Access Compliance Report

Public Rights-of-Way

Intersection ID: 13184	Main Street: S_MINT_ST	Cross Street: S_MINT_ST	Location: SW
ADA ID: 6AA56C0A3BE2	Ramp Type: Perp	Initial Pass/Fail: Fail	Overall Compliance: No
		Severity Score: 37.5

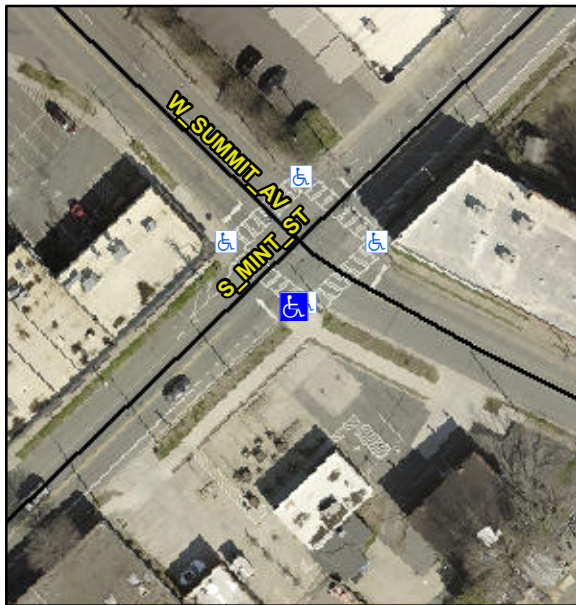
Not Found, R304.2.2, R304.5.3

Compliance	Description	Data	Compliance	Description	Data
N/A	Ramp Length (in)	96.0	No	Ramp Slope (%)	10.1
Yes	Ramp Width (in)	102.0	No	Ramp XSlope (%)	8.1
N/A	Flare Type LT	N/A	N/A	Flare Type RT	N/A
N/A	Flare Slope LT (%)	N/A	N/A	Flare Slope RT (%)	N/A
N/A	Flare Traversable LT?	N/A	N/A	Flare Traversable RT?	N/A
N/A	Landing Length (in)	N/A	N/A	DWS Provided?	N/A
N/A	Landing Width (in)	N/A	N/A	DWS Contrast?	N/A
N/A	Landing Slope (%)	N/A	N/A	DWS Length (in)	N/A
N/A	Landing X Slope (%)	N/A	N/A	DWS Full Width?	N/A
N/A	Landing Curb? (Y/N)	N/A	N/A	DWS Offset (in)	N/A
N/A	Shared Landing?	N/A			
N/A	Gutter Ponding?	N/A	N/A	Gutter Slope (%)	N/A
N/A	Gutter Lip Ht (in)	N/A	N/A	Gutter X Slope (%)	N/A
N/A	Painted X Walk1?	Yes	N/A	Painted X Walk2?	N/A
	X Walk 1 Direction	To NW		X Walk 2 Direction	N/A
N/A	X Walk 1 Width (in)	105.0	N/A	X Walk 2 Width (in)	N/A
	X Walk 1 Slope (%)	3.8		X Walk 2 Slope (%)	N/A
	X Walk 1 X Slope (%)	1.5		X Walk 2 X Slope (%)	N/A

**Remove & Replace Entire Ramp.
Restripe Crosswalk.**
